ACOUSTICAL REPORT

Re: Office of Cable Television Relocation to 1899 9th Street, NE
Acoustical Privacy

Re: Office of Cable Television Relocation to 1899 9th Street, NE
Acoustical Review

Ms. Vivian Rey
JVP Engineers, P.C.
5101 Wisconsin Ave, NW
Suite 400
Washington DC 20016Re: Office of Cable Television Relocation to 1899 9th Street, NE
Site Noise; Acoustical Privacy Addendum

Figure 2. Photo of One Representative Wall Penetration in Electrical Room

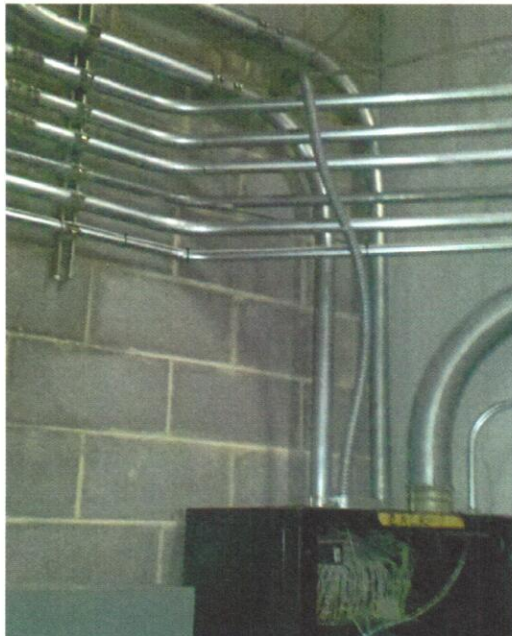
From electrical 044 to large studio A the rating was only NIC 58, and from electrical 043 to large studio A the rating was only NIC 52. Likewise, from electrical 044 to small studio B the rating was only NIC 55, and from electrical 043 to small studio the rating was only NIC 48. In each of these cases there was significant sound leaking through wall penetrations. We could see one such hole roughly 10 feet above the floor (see the top of Figure 2), and we could hear leaks roughly 10 and 20 feet above the floor in each case.

- From EMG power to large studio A we recommend packing back insulation between the duct and the concrete block to better seal it.
- From electrical 043 and 044 to each of the studios we recommend sealing all wall penetrations on both the electrical room side and the studio A/B sides to be air tight. Use acoustical sealant for gaps up to 3/8" wide, and tightly pack fiberglass batt insulation into the gap if it is 1/2" or more wide.

Figure 3. Raised Floor into Small Studio B

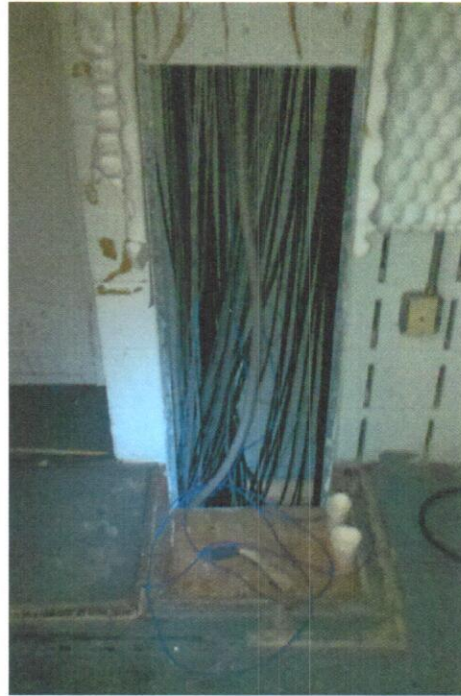
From Audio B to small studio B the rating was only NIC 58. Likewise from Audio A to large studio A the rating was only NIC 54. In each case, there is a significant leak at the raised floor / walker duct under the wall (see Figures 3 and 4).

- From Audio B to small studio B and from Audio A to large studio A at the raised floor / walker ducts, sound is leaking to/from the two studios. We noticed that the built-out areas shown in Figures 3 and 4 do not show up on the architectural floor plan. We recommend adding an additional layer of 5/8" gypsum board to the three sides of these built-out areas shown in Figures 3 and 4 for the full height. In addition, use neoprene gaskets such as Pemko S88 on all four sides for the removable plywood access panels on each end, and pack at least 3 feet of batt insulation into the wall and floor on each end of these paths.

Figure 1. Measured Average Reverberation Times

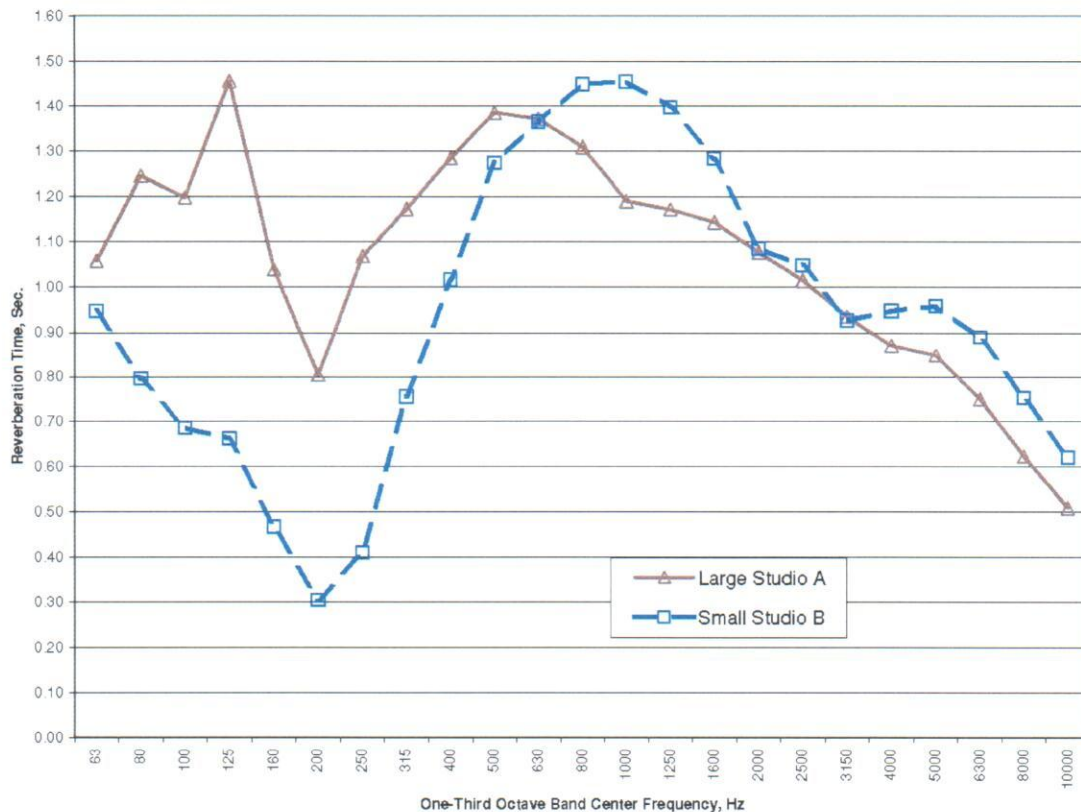
The reverberation time is the amount of time it takes a loud sound to fade after it ends and become inaudible. The reverberation time is typically measured or predicted in various frequency bands either one octave wide or one-third of an octave wide. We measured reverberation times in one-third octave bands at various locations in each studio and the averages are presented in Figure 1.

seconds, respectively (these were taken from the Master Handbook of Acoustics). These goals are most important at frequencies of 250 Hz and higher – slightly longer times are fine at lower frequencies since speech sound is less significant at those frequencies. It can be seen from Figure 1 that the reverberation times in the large Studio A are far above the goal of 0.7 seconds at frequencies of 250 to 3150 Hz, and the times in the small Studio B are far above the goal of 0.5 seconds at frequencies of 315 to 8000 Hz.

3. New 2" thick fabric-faced fiberglass panels would be added with an area as needed to reach the desired reverberation times. We predict that this would be achieved if the new acoustical panels are used on all four walls in a 24-foot tall band (i.e., approximately 6700 sf) for the large studio A and in a 15-foot tall band (i.e., approximately 2350 sf) for the small studio B. If these areas are too costly for the budget, use as much area as possible. The cost would be lower using panels which have the fabric adhered to the fiberglass as opposed to stretched fabric panels.
